Northeast Ohio Regional Sewer District

July 3, 1995

Re: Advanced Medical Systems, Inc. Proposed Reconnection

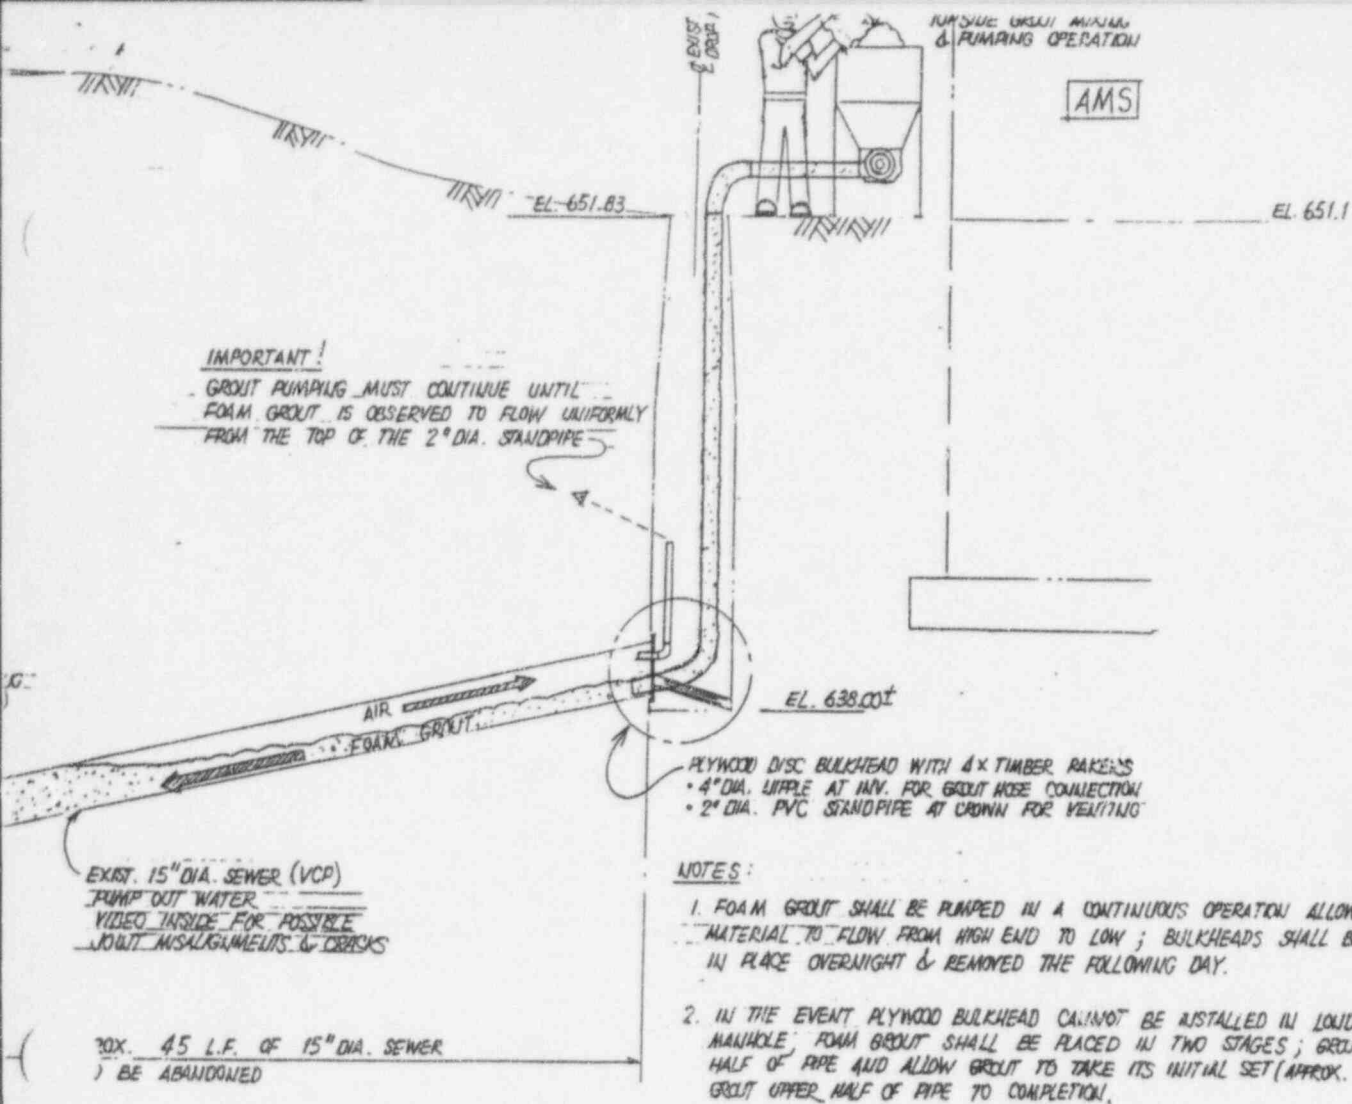
1. SUBMIT GROUT DESIGN MIX; REVIEW VIDEO OF EXISTING 15" DIA. LATERAL FOR JOINT MISALIGNMENTS & CRACKS (GROUT MIX CAN BE MODIFIED TO ACCOMMODATE CONDITIONS)
2. PROVIDE NEW STD. DROP MAINHOLE (WHEN DROPPING FLOWS 2.5' OR GREATER) CONNECT FOUNDATION DRAIN
3. NEW SAMPLING MAINHOLE TO MEET MERSD CRITERIA (PG. 3, PAR. 16, MERSD LETTER OF 4/18/84)
4. MAINTAIN NEW CONNECTION ANGLE TO NOT GREATER THAN 90°
5. A BASIN (AS REQUIRED); CONNECT TO NEW STD. DROP MAINHOLE
